Technical Information Bulletin

16-036**windup
bracket****windup
spring**

T270 & T370 ADB/RSD Stopper Campaign

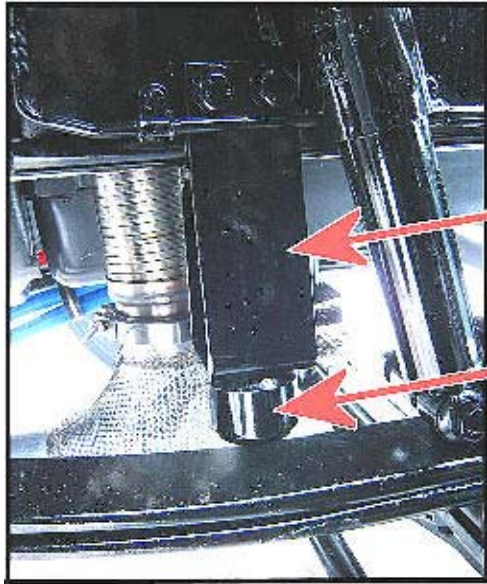
Chassis listed may have been built with the wrong size front spring stopper. See Background section for description of performance characteristics.

Different chassis configurations require different stopper sizes and on the chassis listed, some stoppers were too long, which will overly restrict spring movement and could result in a rough ride.

Inspect and, if necessary, service all chassis affected that enter your dealership, even if the customer has no issue with the chassis. Use the procedure below. Review DWC or SIR online systems to verify that campaign "16-36" is still open or already completed prior to performing this repair.

<u>Quantity</u>	<u>Part Number</u>	<u>Description</u>
2	B11-1041-2	Windup Bumper Bracket
4	HWC12248	Hardened washer (for rubber bumper mount)
2	HWC10050	M10 hex bolt (for rubber bumper mount)
2	A00180-75AG00	Rubber bumper
4	60500ZYEL	16mm frame bolt
4	HWC07936	5/8" frame mount washer
4	HWC12501	Nut
1	shop supplies	spray paint
